SUBJECT: Engineering Practice Study (EPS), Request for Comments on Proposal for new Military Specification documents for Miniature, Lightweight, Circular Connectors. Project Number 5935-2018-049.

**SUBJECT: PREPARATION OF NEW MILITARY SPECIFICATION
DOCUMENTS FOR STANDARDIZED LIGHTWEIGHT CIRCULAR
CONNECTORS.**

STUDY PROJECT NUMBER 5935-2018-049

FINAL REPORT – MIL-DTL-#####

Figure 1, Receptacle and Plug Master Key/Keyway Configuration (image taken from pages 68 & 69)

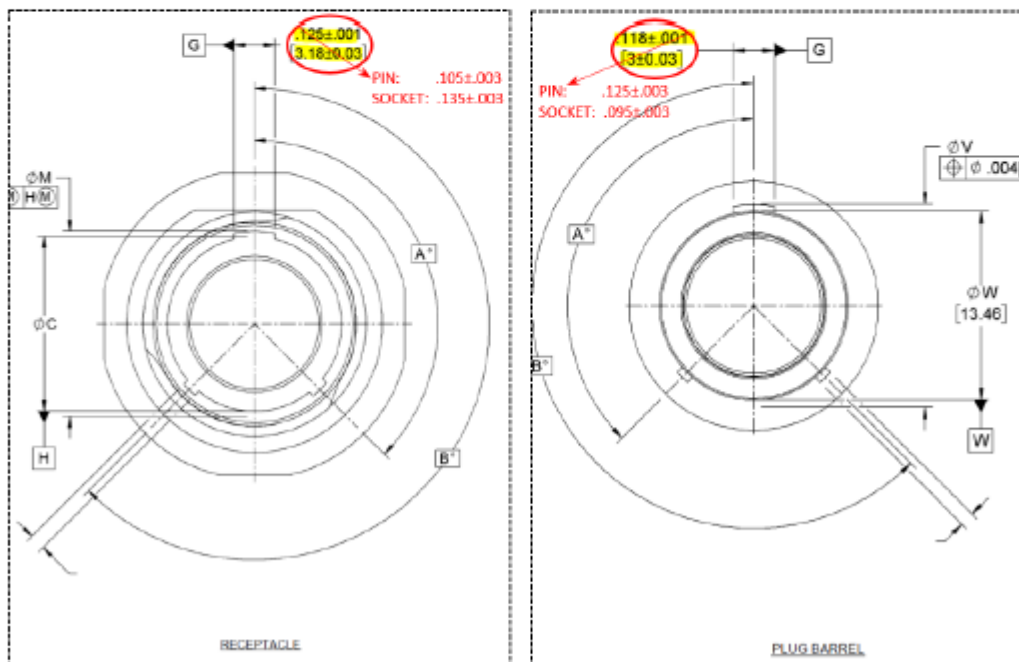
Comment #25 (Glenair). Page 15 and fig 4 on pages 68-69..

1. Para 3.6.3 Pin to pin mating prevention. To meet this critical requirement, Glenair recommends the following change to Figure 4. Main key / keyway polarization:

- Different master key/keyway widths are required on pin-type and socket-type connectors in order to prevent pin-to-pin mating as required by paragraph 3.6.3 of the subject specification. This method is used in construction of MIL-DTL-38999 series IV connectors.
- Additionally a tolerance change from: $\pm.001$ to: $\pm.003$ is also required to increase the manufacturability of the connectors. This tolerance reflects the master key/keyway of MIL-DTL-38999.

The following master key/keyway configuration is proposed to remedy this requirement:

Pin-Type Connector	Socket-Type Connector
Plug, key width	$.125 \pm .003$	$.095 \pm .003$
Receptacle, keyway width	$.105 \pm .003$	$.135 \pm .003$

Comment #25 DLA response: Discussed proposal during teleconference on 24 April 2018 –Proposed changes would result in major design changes. Military applications require the design defined in the rough draft. Consensus is to defer proposal for possible “series 2” to the proposed mil spec.

Figure 2, Receptacle and Plug Minor Key/Keyway Configuration

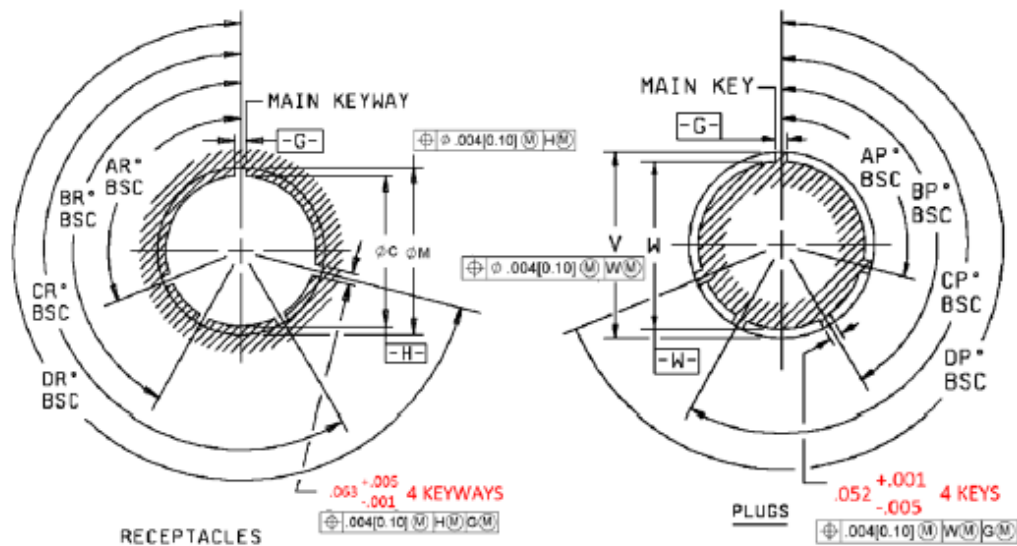
Comment #26 (Glenair).

2. **Minor key/keyway configuration.** In blind mating conditions, the 3 key / keyway construction of the proposed connector can allow the plug connectors to “rock” side to side in the region where not supported by polarization keying (3 O’clock and 9 O’clock regions). This condition can lead into cross threading of plug connector’s coupling thread and the receptacle connector thread:

- In order to mitigate the risk of cross threading, remove possible rocking during mating, and improve overall mateability, an additional two minor key/keyways must be added.
- This 5 key/keyway configuration reflects MIL-DTL-38999 series 3.

The following key/keyway configuration is proposed to remedy this risk:

Key and keyway arrangement identification letter	Minor key/keyway rotations			
	AR° or AP° BSC	BR° or BP° BSC	CR° or CP° BSC	DR° or DP° BSC
N	105	140	215	265
A	102	132	248	320
B	80	118	230	312
C	35	140	205	275
D	64	155	234	304
E	91	131	197	240

Comment #26 DLA response: The proposal was discussed during teleconference on 24 April 2018 (also see comment #1). Proposed changes would result in major product design changes. The proposed design would not be interchangeable in current applications. Military applications require the design defined in the rough draft. Consensus is to defer proposal for possible “series 2” to the proposed mil spec.

Figure 4, Receptacle intermateability dimensions (from 8935-2018-049 pages 56 & 57, figure 1)

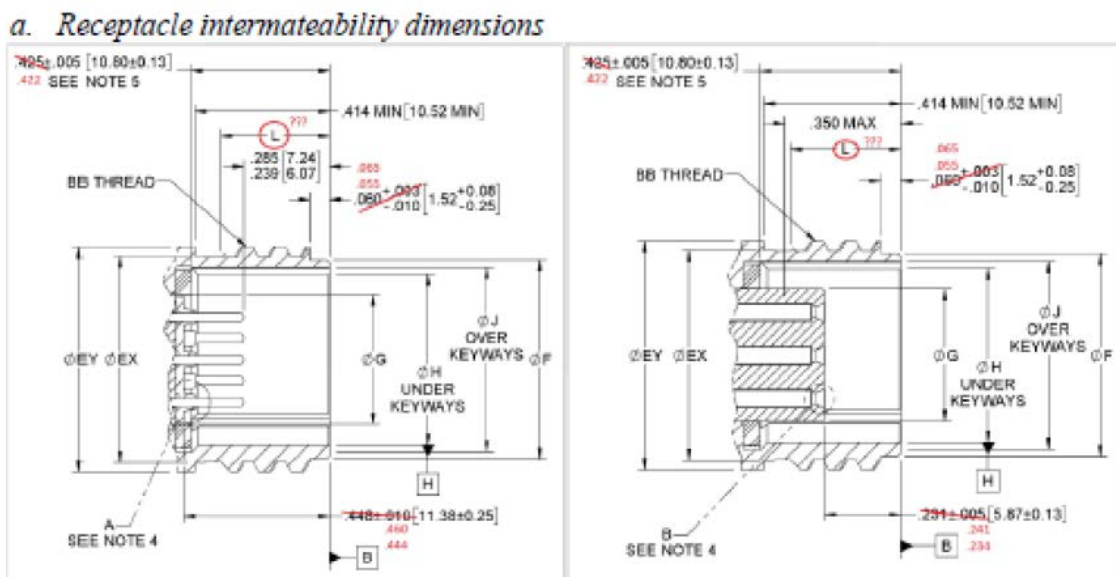
Comment #34 (Glenair). Glenair recommends the following changes to dimensional details on page 56 thru 77.

Comment #34 DLA response for RECEPTACLE INTERMATEABILITY (FIGURE 1 in rough draft). Proposal suitable for a “series 2” which is currently beyond the scope of this project. See previous comment #1.

Figure 6, Plug intermateability dimensions (from 8935-2018-049 page 60, figure 2)

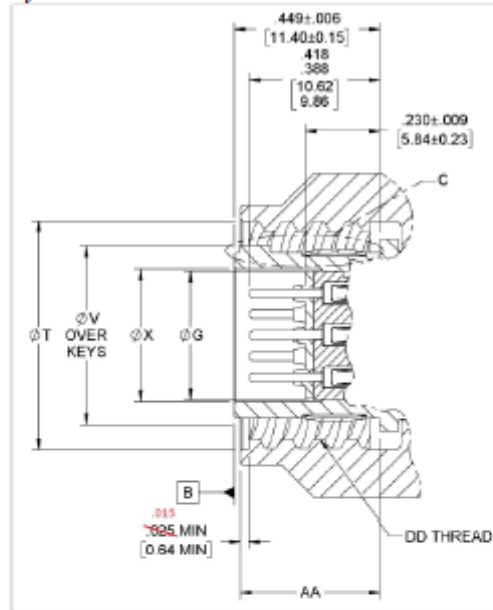
III. SUMMARY OF COMMENTS – **Continued.**3. Glenair.Comment #35 (Glenair). – **Continued.***b. Plug intermateability dimensions*

Comment #35 DLA response for PLUG INTERMATEABILITY (FIGURE 2 in rough draft). Proposal suitable for a “series 2” which is currently beyond the scope of this project. See previous comment #1.

Figure 8, Interface design (from 8935-2018-049 page 66, figure 3)

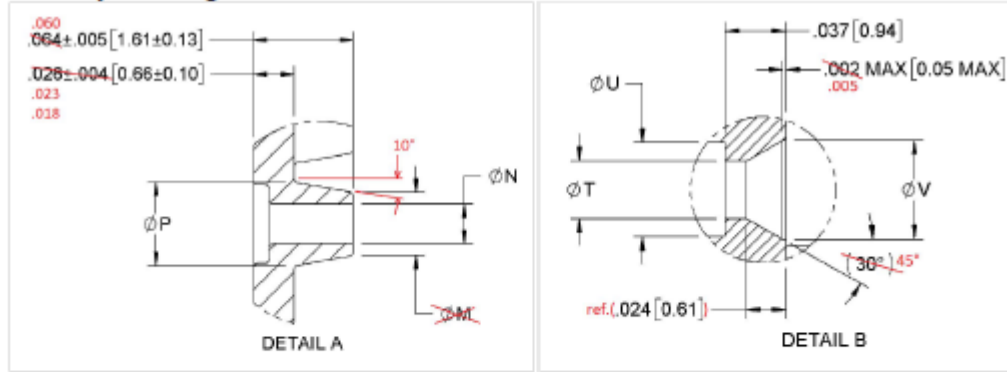
Comment #36 (Glenair) - Continued.

c. Interface Design

Comment #36 DLA response for PIN CONTACT RAISED SEAL BARRIER / INTERFACE and SOCKET CONTACT CAVITY INTERFACE (FIGURE 3 in rough draft). Proposal suitable for a "series 2" which is currently beyond the scope of this project. See previous comment #1.

Figure 10, Accessory Interface Dimensions (from 8935-2018-049 page 70, figure 5)

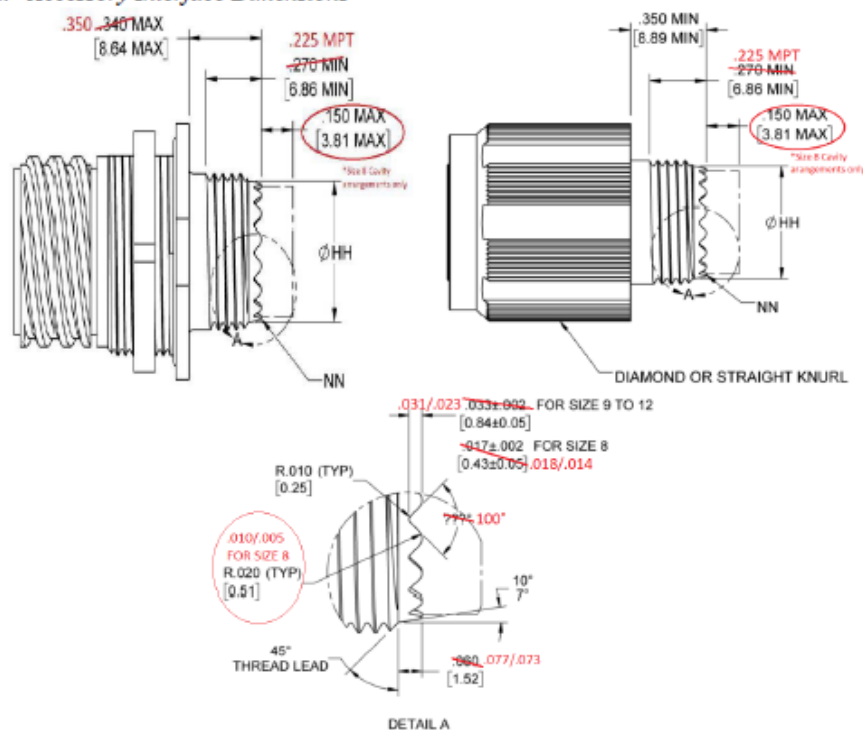
Comment #35 (Glenair) – Continued

d. Accessory Interface Dimensions

Comment #35 DLA response for REAR ACCESSORY INTERFACE (FIGURE 5 in rough draft). During preparation of the upcoming initial draft, proposed changes to be discussed further with prospective QPL connector manufacturers in order to develop consensus. . Also, sizes 13 and 21 will be added to the table (see comment #3).

Figure 12, Integral Backshell Interface Dimensions (from 8935-2018-049 page 72, figure 6)

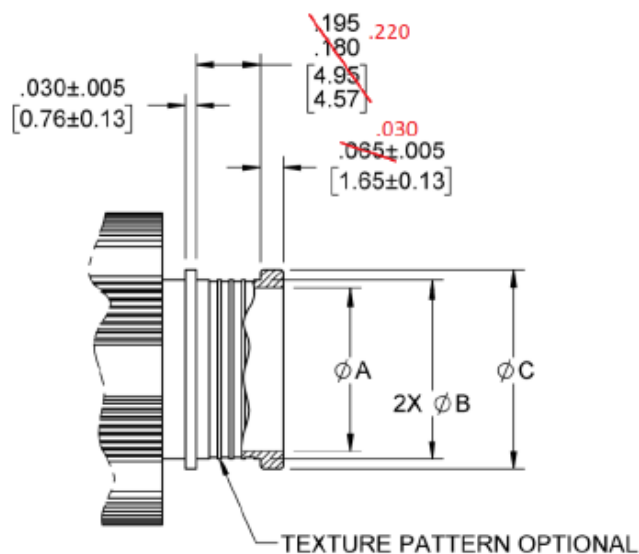
III. SUMMARY OF COMMENTS – **Continued.**3. Glenair. – **Continued.**Comment #36 (Glenair) – **Continued***e. Integral Backshell Interface Dimensions*

Comment #36 DLA response for CONNECTOR – INTEGRAL BACKSHELL INTERFACE (FIGURE 6 in rough draft). During preparation of the upcoming initial draft, proposed changes to be discussed further with prospective QPL connector manufacturers in order to develop consensus. . Also, sizes 13 and 21 will be added to the table (see comment #3).

Figure 15, Size 20HD Contact, Pin and Socket (from 8935-2018-049 page 74, figure 8)

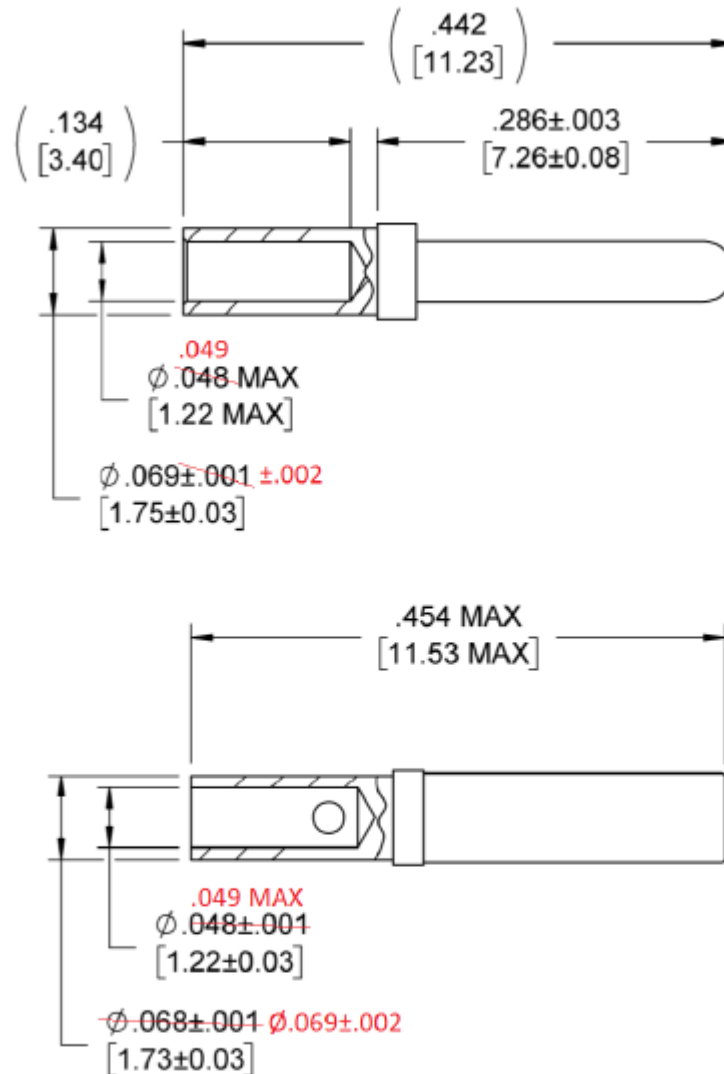
Comment #37 (Glenair) – **Continued**

g. Size 20HD Contact, Pin and Socket

Comment #37 DLA response for proposed changes, Size 20HD Pin and Socket contacts (FIGURE 8 in rough draft). During preparation of the upcoming initial draft, proposed changes to be discussed further with prospective QPL connector manufacturers in order to develop consensus.

Figure 14, Size 23 Contact, Pin and Socket (from 8935-2018-049 page 73, figure 7)

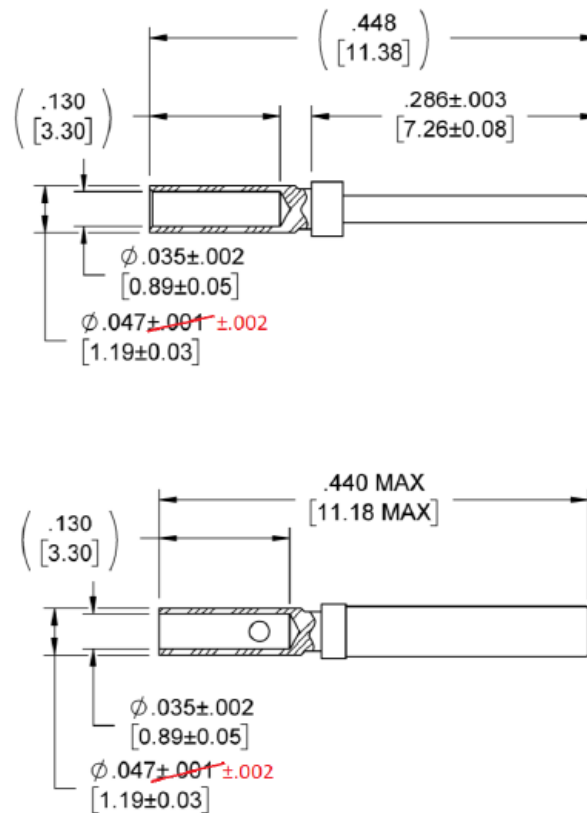
Comment #38 (Glenair) – Continued

f. Size 23 Contact, Pin and Socket

Comment #38 DLA response for proposed changes, Size 23 Pin and Socket contacts (FIGURE 7 in rough draft). During preparation of the upcoming initial draft, proposed changes to be discussed further with prospective QPL connector manufacturers in order to develop consensus.

Figure 16, Spanner Nut Dimensions (from 8935-2018-049 page 75, figure 9)

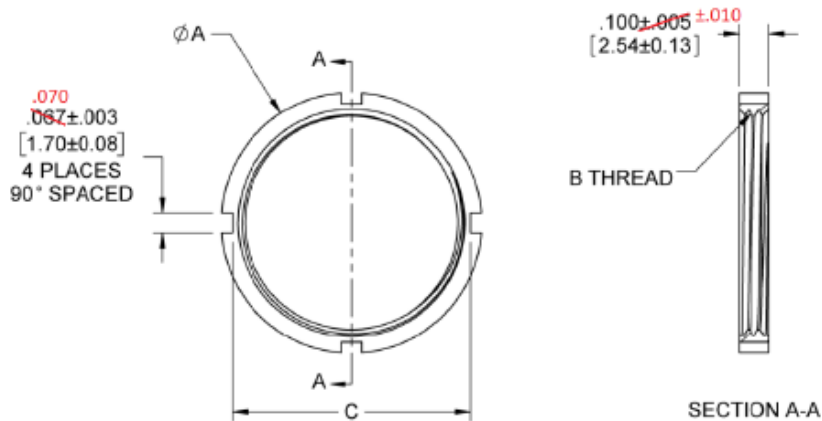
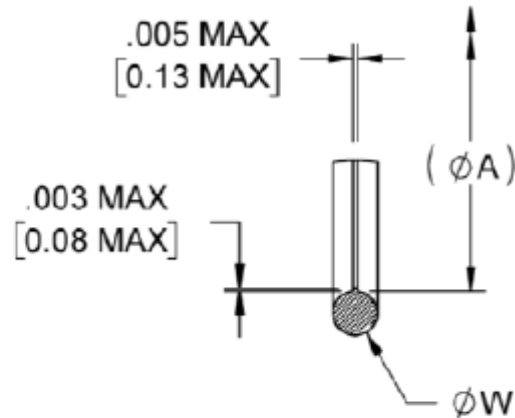
Comment #39 (Glenair) – Continued

h. *Spanner Nut Dimensions*

Comment #39 DLA response for proposed changes, Spanner Nut (FIGURE 9 in rough draft). During preparation of the upcoming initial draft, proposed changes to be discussed further with prospective QPL connector manufacturers in order to develop consensus. Also, sizes 13 and 21 will be added to the table (see comment #3).
